SUBJECT: ISSUANCE OF AMENDMENTS - BRAIDWOOD STATION, UNITS 1 AND 2
(TAC NOS. MA0696 AND MA0697)

SAFETY EVALUATION BY THE OFFICE OF NUCLEAR REACTOR REGULATION
RELATED TO AMENDMENT NO. 95 TO FACILITY OPERATING LICENSE NO. NPF-72
AND AMENDMENT NO. 95 TO FACILITY OPERATING LICENSE NO. NPF-77

BRAIDWOOD STATION, UNIT NOS. 1 AND 2

ATTACHMENT TO LICENSE AMENDMENT NOS. 95 AND 95

FIGURE 3.4-1
DOSE EQUIVALENT I-131 REACTOR COOLANT SPECIFIC ACTIVITY
LIMIT VERSUS PERCENT OF RATED THERMAL POWER WITH THE REACTOR
COOLANT SPECIFIC ACTIVITY > $1\mu\text{Ci/GRAM}$ DOSE EQUIVALENT I-131*

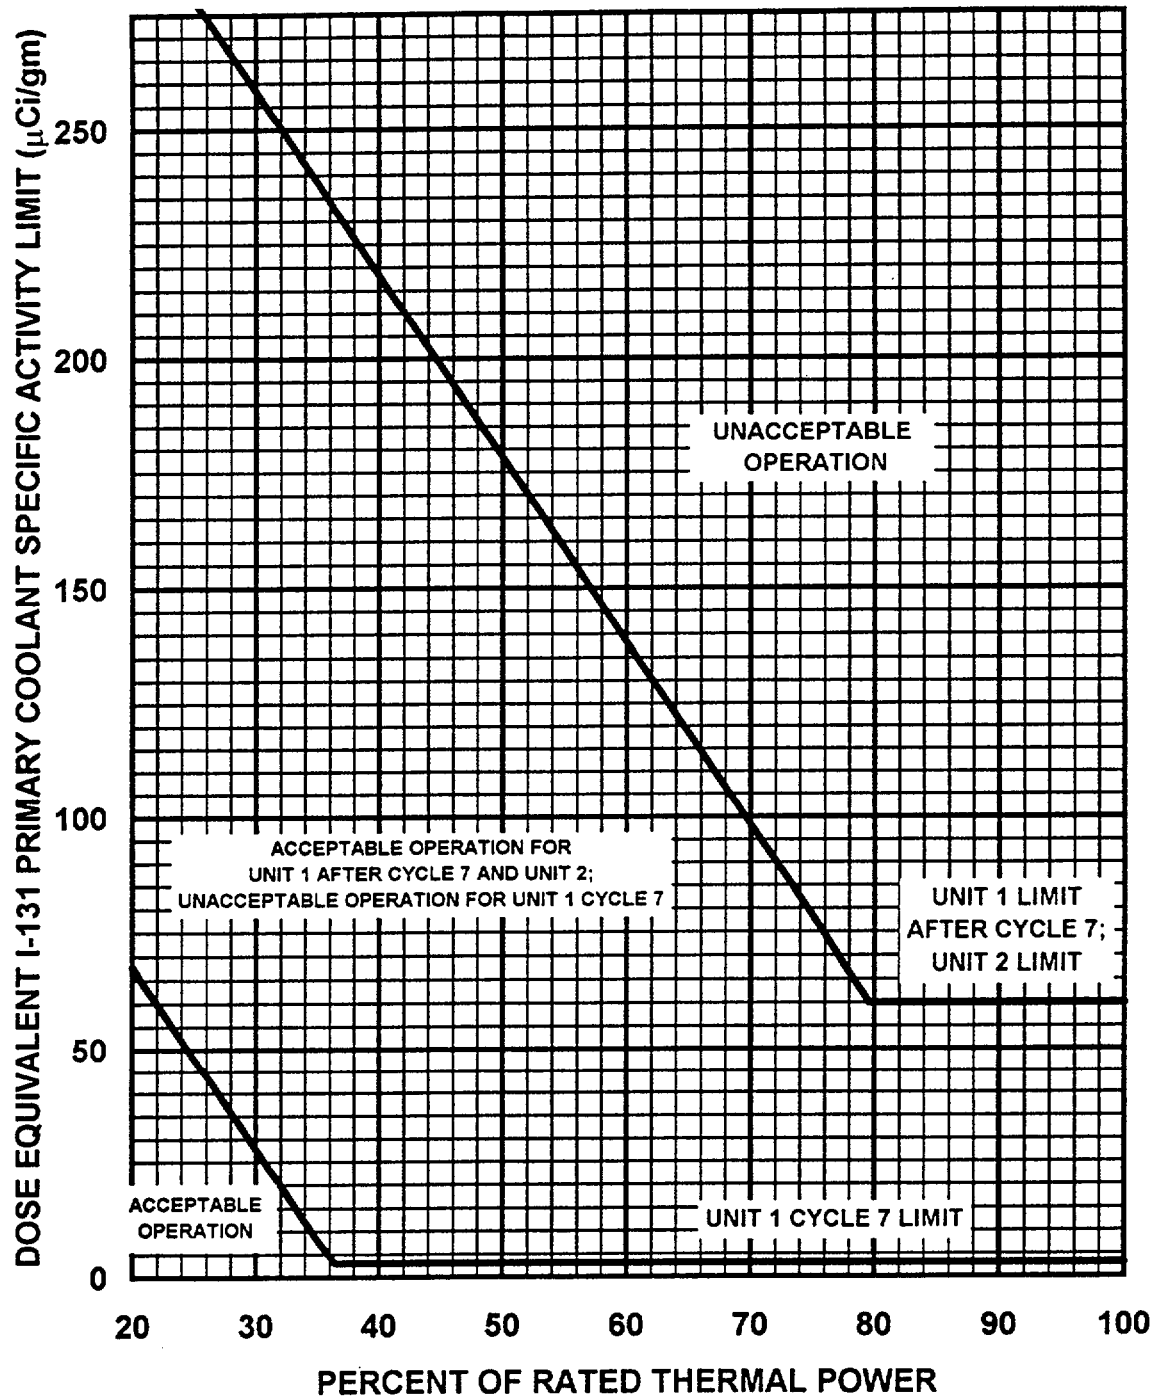
* For Unit 1 through Cycle 7, Reactor Coolant Specific Activity > $0.05\mu\text{Ci/Gram}$ DOSE EQUIVALENT I-131.
